**From:** Oswald, Hank  
**Sent:** Monday, April 30, 2018 10:49 AM  
**To:** 'GARY LANE'  
**Cc:** Ann Zamudio <clevergrethel99@gmail.com> (clevergrethel99@gmail.com); GREGORYREMODELING@GMAIL.COM; Williams, Jeffrey  
**Subject:** RE: Perc Cert Plan\_14788 Carriage Mill Road

**RE:** 14788 Carriage Mill Road  
Woodbine, MD 21797

The amended perc cert plan for 14788 Carriage Mill Road has been reviewed with the following comments:

REVISED PERCOLATION CERTIFICATION PLAN

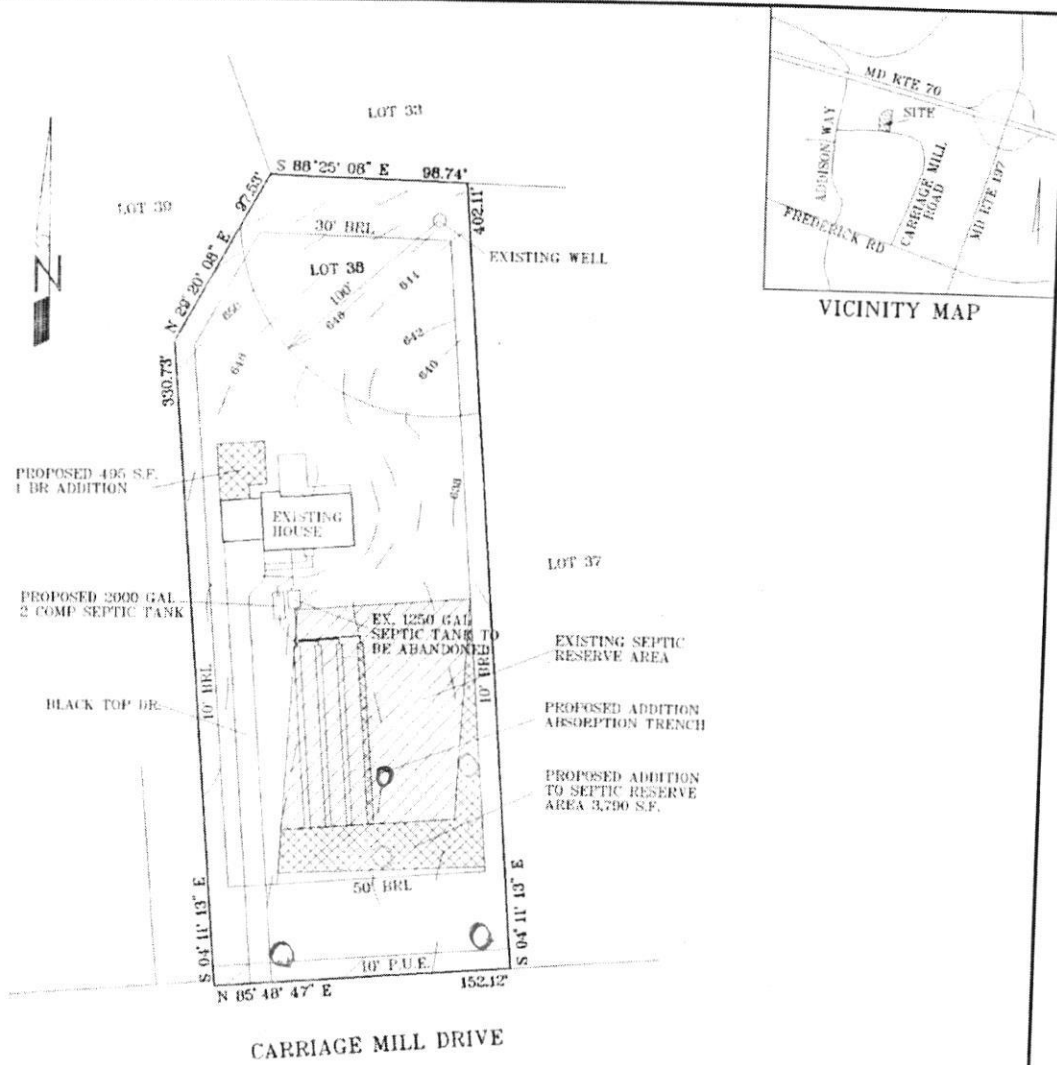
Good morning. As I mentioned in past correspondence and over the phone, the gas line (and electric) cannot be within the approved Sewage Disposal Area (SDA). On your latest plan received on April 25th, you have the lines labeled gas and electric within the SDA (See attachment). They should be located outside the proposed SDA at least 5 to 10 feet. Either they were mislabeled then or mislabeled now but this will need to be addressed.

Please have Miss Utility field locate all lines (i.e. gas, electric, phone) and plot them on the plan accordingly. If the gas and electric lines are in fact in the middle or right side of the SDA, they will need to be relocated outside the SDA.

- 1.) Label lines (i.e. Phone, Cable) inside the SDA. Gas lines may not be within the SDA.
- 2.) Revise Calculations
  - *Area of trench required* =  $5 \times 150 = 750\text{gpd}/0.8 = 937.5$

- *Length of trench required* =  $937.5/3\text{ft.} = 312.5$  (6<sup>th</sup> column)
  - *Trench Reduction Factors Column 9)*  
Initial = .71  
First Replacement = .45  
Second Replacement = .45

- *Required Length of Trench (LF)*  
Initial = 221.9 (The existing system will be considered the initial system)  
First Replacement = 140.6 (2 – 70 ft. trenches)  
Second Replacement = 140.6 (2 – 70 ft. trenches)

- *Adjusted Length of Required Trench (Column 10)*  
Existing System = 221.9  
First Replacement = 140.6  
Second Replacement = 140.6
- 3.) Change system names in chart to match system names on plan

- 4.) Add existing perc test hole locations back to plan
- 5.) Provide 2 copies of the plan for signature (add 1 additional copy for your records)

- The total square foot of absorption area should be 937.5 (not 312.5).
- The total linear feet of trench should be 312.5 LF (before sidewall credit)

- The #s within the column called "Adjusted Length of Required Trench" are in incorrect.
- Some of the perc test holes disappeared on this version of the plan.
- Reread note 11. I think the # should be 5 (not 4 bedrooms)
- Label lines within the SDA (phone, cable etc. and add to note #13)
- Match symbol for well box to plan.

Let's simplify this a bit. Let's use one symbol for the old and new SDA. You don't have to use a symbol for the buffer. The SDA will simply be two areas divided down the middle by the gas line. Eliminate unusable portion of the SDA along the property lines and simply show the other lines outside the SDA. Send me an e-copy and I will look at it again.

As a follow-up on our earlier telephone conversation, we cannot accept a note with statement to relocate the utilities at time of installation of a replacement system. However, we can accept a plan showing the lines (gas and power) outside of the SDA. You may create a 5 foot buffer on either side the gas line and a 5 foot buffer setback to the power line on the side of the SDA. If you choose this option, you will have to probably relocate some of the proposed trenches. Otherwise, the gas and power lines have to be physically relocated outside the SDA and shown on plan before approval.

REVISED PERCOLATION CERTIFICATION PLAN

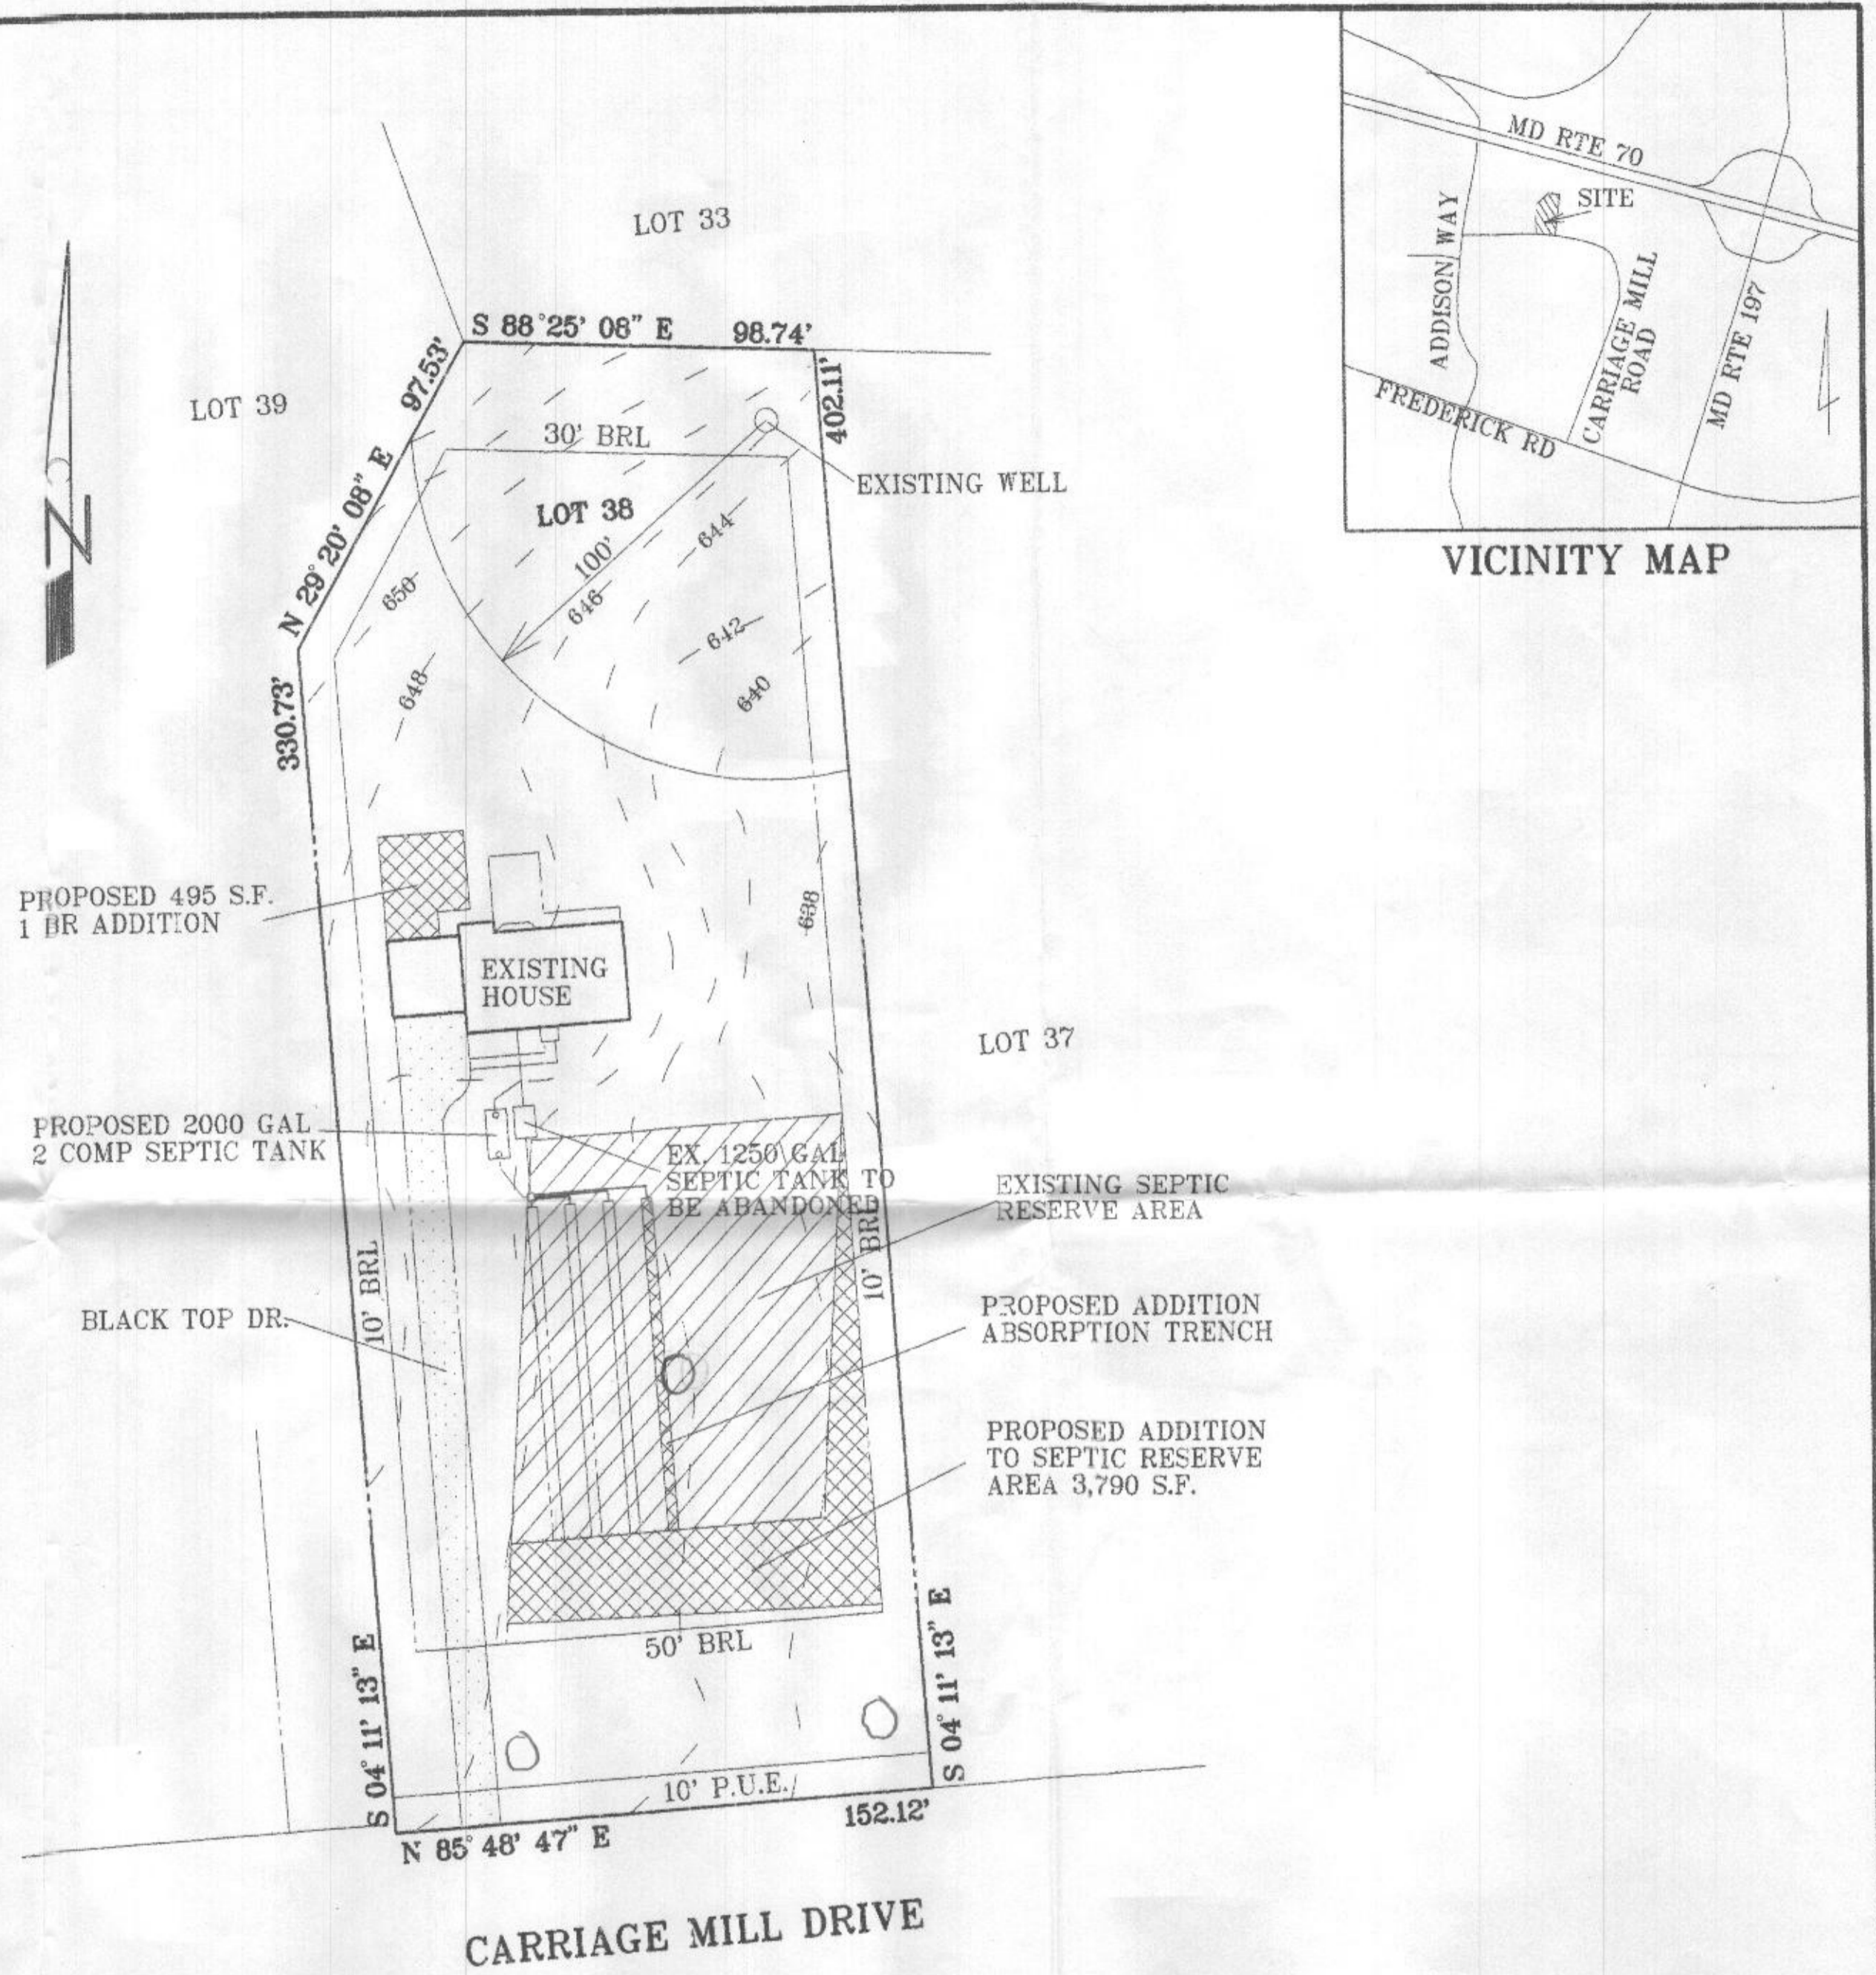
Good morning. As I mentioned in past correspondence and over the phone, the gas line (and electric) cannot be within the approved Sewage Disposal Area (SDA). On your latest plan received on April 25th, you have the lines labeled gas and electric within the SDA (See attachment). They should be located outside the proposed SDA at least 5 to 10 feet. Either they were mislabeled then or mislabeled now but this will need to be addressed.

Please have Miss Utility field locate all lines (i.e. gas, electric, phone) and plot them on the plan accordingly. If the gas and electric lines are in fact in the middle or right side of the SDA, they will need to be relocated outside the SDA.
